**Subject:** Ring Spacer, HP Seal P/N 70-0407 to be eliminated

UNITS AFFECTED: 3P20 Titan Series (Manifold S/A 70-6122, 70-6122M), 5P50 Titan Series (Manifold S/A 70-6120, 70-6120M).

**FIG 1**  
The Spacer Rings, HP Seal were eliminated in the modified manifold.

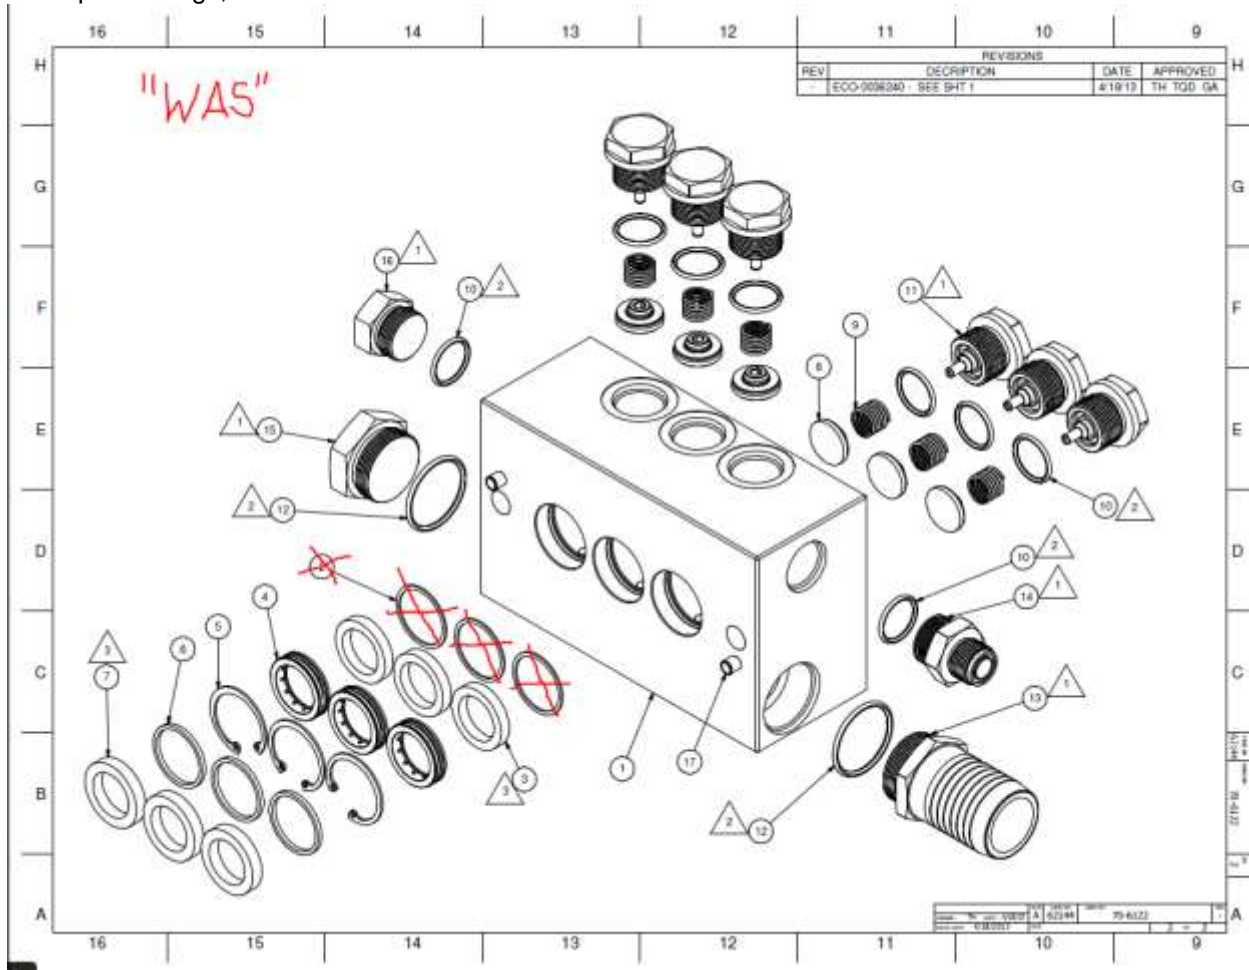
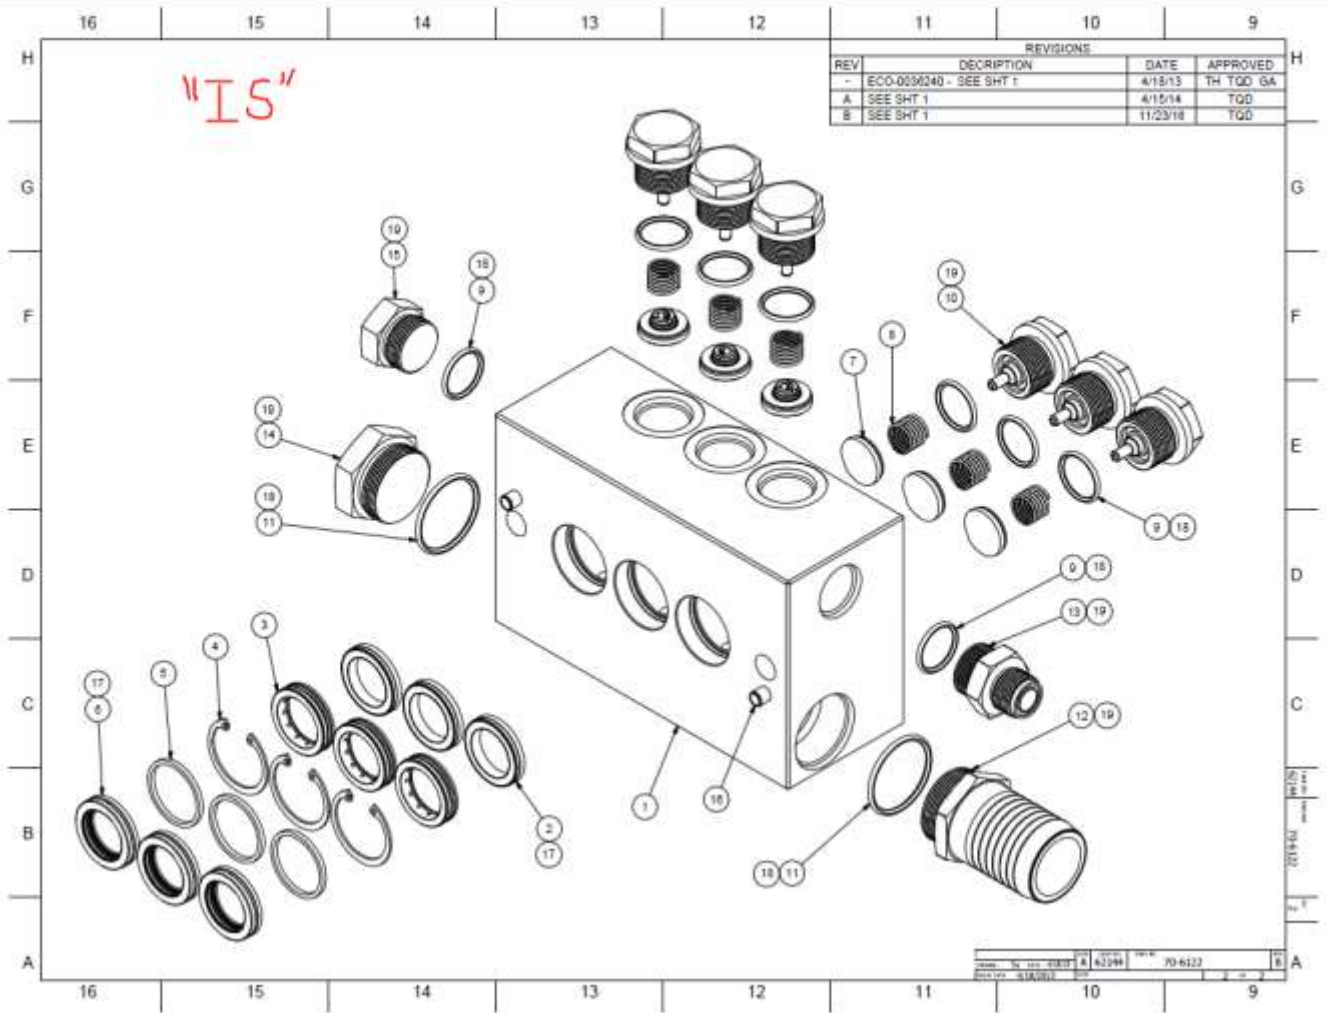
The Ring Spacers for HP Seal P/N 70-0407 are made with the same material of the manifold (titanium grade 2) so that in the process of machining the crankcase, these Ring Spacers can be built in the manifold so that they will not be a loosened parts. The re-designed of the crankcase will have to eliminate 3 ring spacers in the manifolds of 3P20 pumps (Manifold S/A 70-6122, 70-6122M), and 5 ring spacers in the manifolds of 5P50 Titan Series (Manifold S/A 70-6120, 70-6120M).

FIG. 4

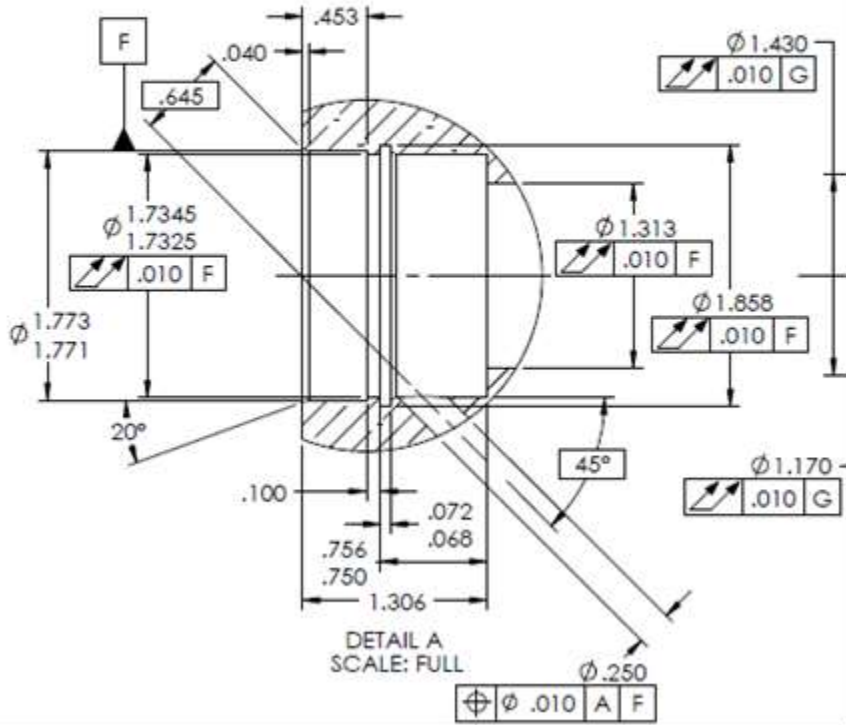
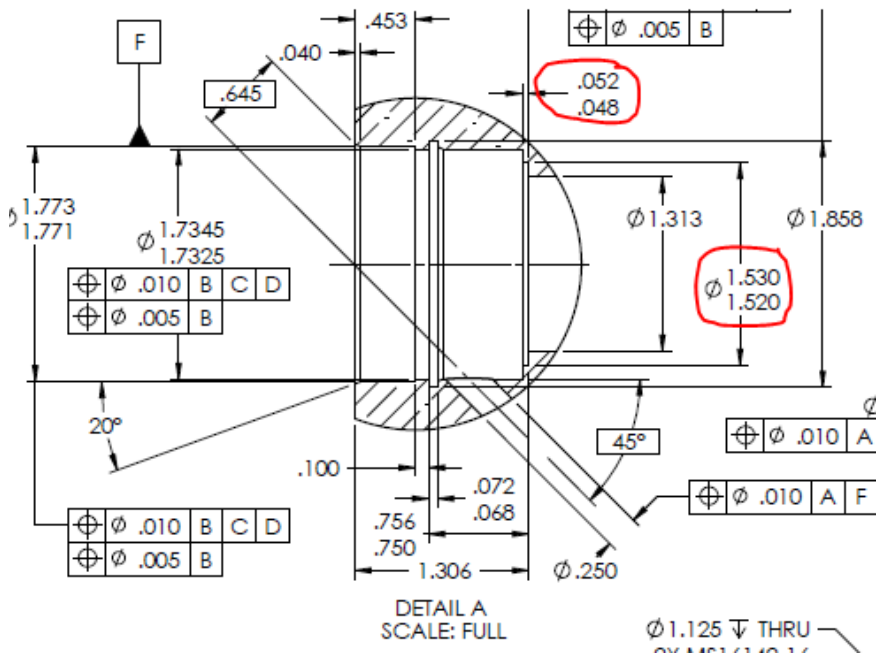
"WAS"

The new feature Dia 1.530/1.520 with .052/.048 was added inside each bore to eliminate the Spacer Ring for HP Seal

"IS"

For all pumps that are built before these Revision letters (that have the manifolds to be made without these rings built in feature), then the ring spacers 70-0407 should be re-used whenever doing maintenance (replacing parts from seal kits).

- Whenever doing the maintenance (replacing the HP Seals) for the manifold, check for the Spacer Rings behind the HP Seals. If the Spacer Rings exist, then the manifold was from the old Rev.
- After removing the HP Seals, check inside the manifold to see the raised up feature (Dia 1.530/1.520 x .052/.048) as shown in FIG 4. If it does not have, then the manifold is from the old Revision, all Ring Spacers are required to use.
